ELECTRICITY INDUSTRY PARTICIPATION CODE
DISTRIBUTED UNMETERED LOAD AUDIT REPORT

UPPER HUTT CITY COUNCIL
AND
GENESIS ENERGY LIMITED

Prepared by: Tara Gannon

Date audit report completed: 8 August 2023

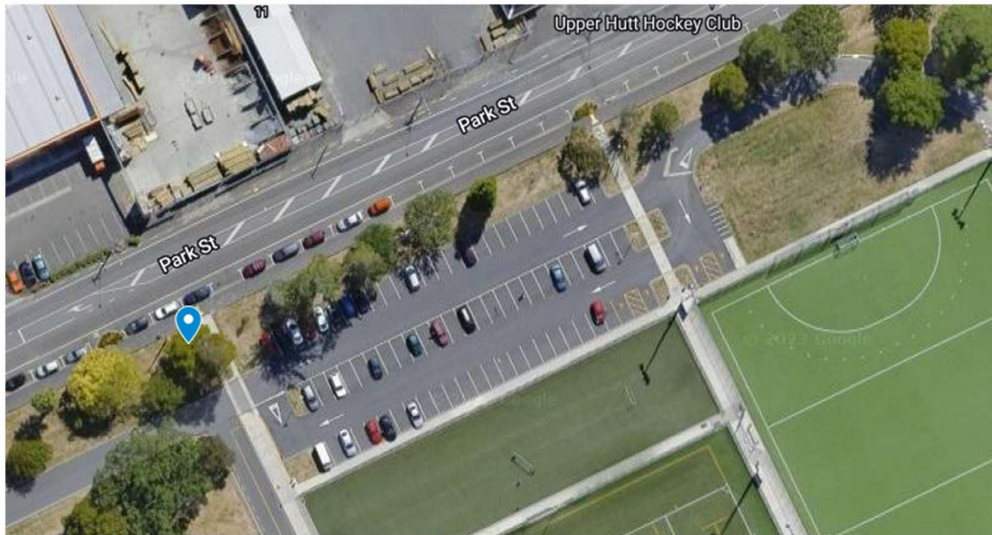
Trentham Memorial Park still has no lights with GPS locations in its carpark off Barton Road. The previous audit recorded that there were two floodlights aimed at the carpark.

Maidstone Park still has no lights with GPS coordinates within its carpark off Park Road. The previous audit recorded that there were seven Phillips HPS lights positioned around the carpark.

The previous audit recommended that Genesis works with UHCC to confirm the ownership and operation of these carpark lights to ensure this load is accounted for, and I have repeated this recommendation.

Recommendation	Description	Audited party comment	Remedial action
Confirm the ownership and operation of carpark lights to ensure this load is accounted for	Confirm the ownership and operation of the carpark lights at Trentham Memorial Park and Maidstone Park to ensure this load is accounted for.	These assets have been investigated. There are some lights in the database from these locations and also some that are not connected to the streetlight circuit which are metered lights, also owned by the Upper Hutt CC.	Investigating
